TABLE 3.6-2 (Continued)
CONTAINMENT ISOLATION VALVES

Attachment II

Justification and Safety Analysis

This proposed change concerns the deletion of isolation valve NI-122B from Table 3.6-2 of the McGuire Technical Specifications. At present this valve is subject to operability requirements (T.S. 3.6.3) and surveillance requirements (T.S. 4.6.3).

Figure 1

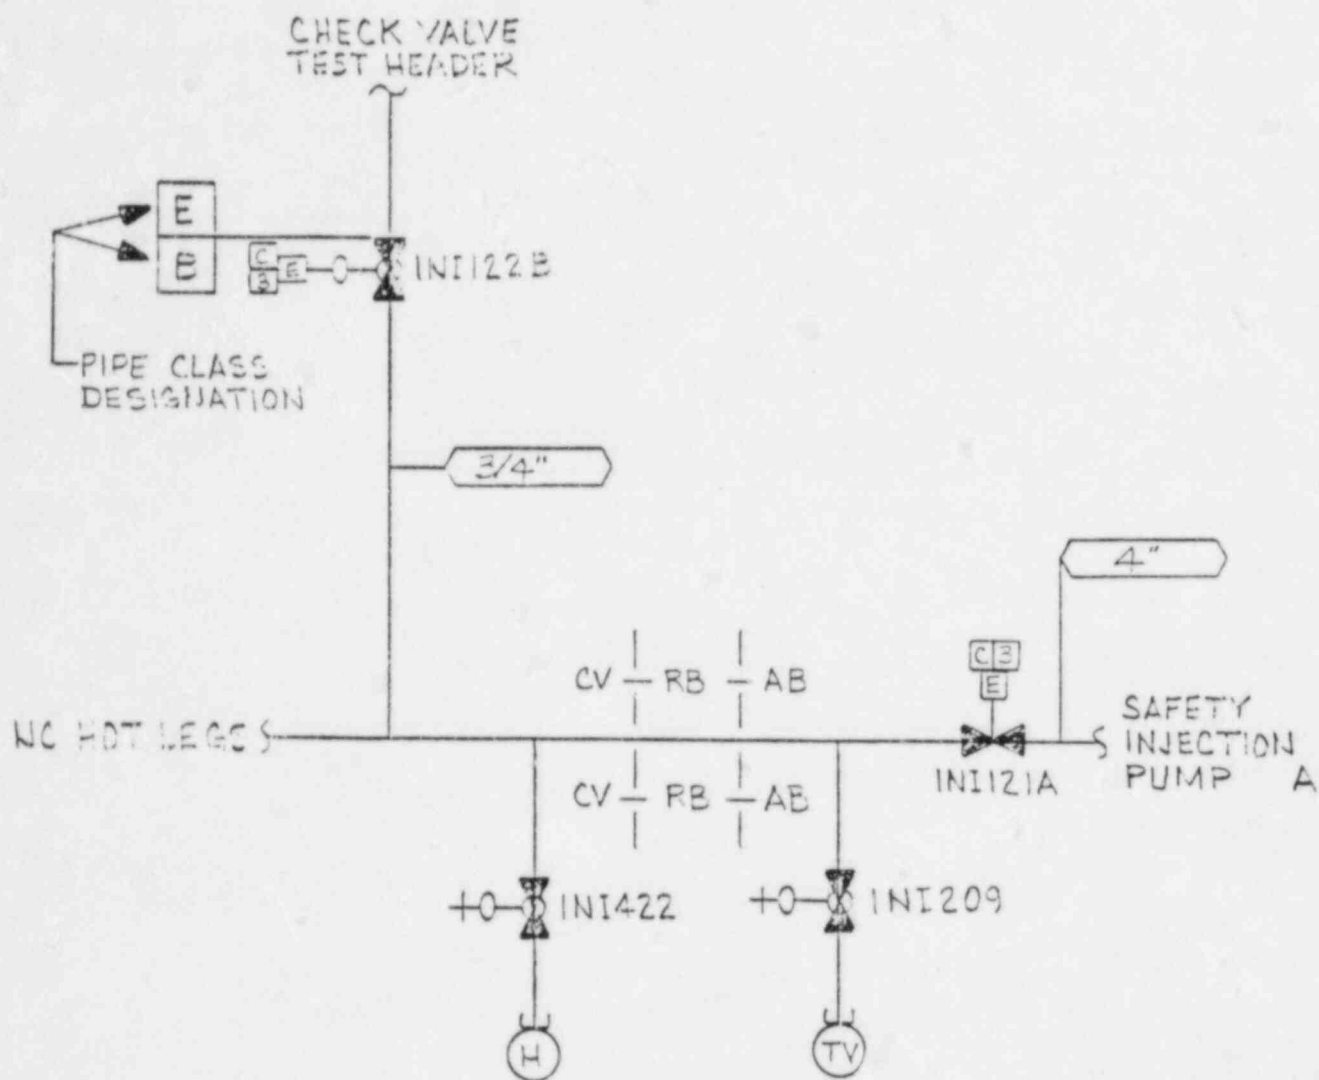
The containment isolation systems are designed to provide the means of isolating fluid systems that pass through penetrations so as to prevent leakage of radioactivity from the containment following a design basis accident. Valve NI-122B is located on a 3/4" line which branches off the 4" Nuclear Safety Injection System (NI) lines as shown in Figures 1 and 2. The 4" NI lines provide safety injection flow to the Reactor Coolant System hot legs, and would be under high pressure following an accident. NI-122B is in a Safety Injection System check valve test header line. This valve is normally closed and would be open only during a plant shutdown. Present administrative controls require verification of all NI valve positions prior to unit startup. If NI-122B was open in an accident situation, the high pressure in the 4"-NI lines would prevent leakage of radioactivity from the containment to the auxiliary building.

Since valve NI-122B does not require an isolation signal (ST), a station modification would eliminate the automatic closure feature for valve NI-122B. The signal is not required for valve NI-122B as it is normally closed during plant operation and controlled administratively. The modification to remove the containment isolation signal (ST) from valves 1NI-122B (Unit 1) and 2NI-122B (Unit 2) will be initiated upon NRC granting the proposed amendment of the Technical Specifications. The proposed changes would eliminate unnecessary surveillance and testing on valves NI-122B and reduce time in Containment thereby reducing personnel exposure.

The Technical Specification change to delete valve NI-122B from the Table 3.6-2, and the modification to remove the containment isolation signal (S_T) from NI-122B, is being proposed as this valve does not require a containment isolation signal (S_T). Valve NI-122B is normally closed during operation and removal of containment isolation signal (S_T) to a valve normally closed during operation does not adversely affect safety. At other times the valve line is full of high pressure safety injection water and would not provide a path for radioactivity releases. The opening and closing of the valve is administratively controlled. The inclusion of an S_T signal on this valve was inadvertent.

Phase A Signal Deletion from INI122B
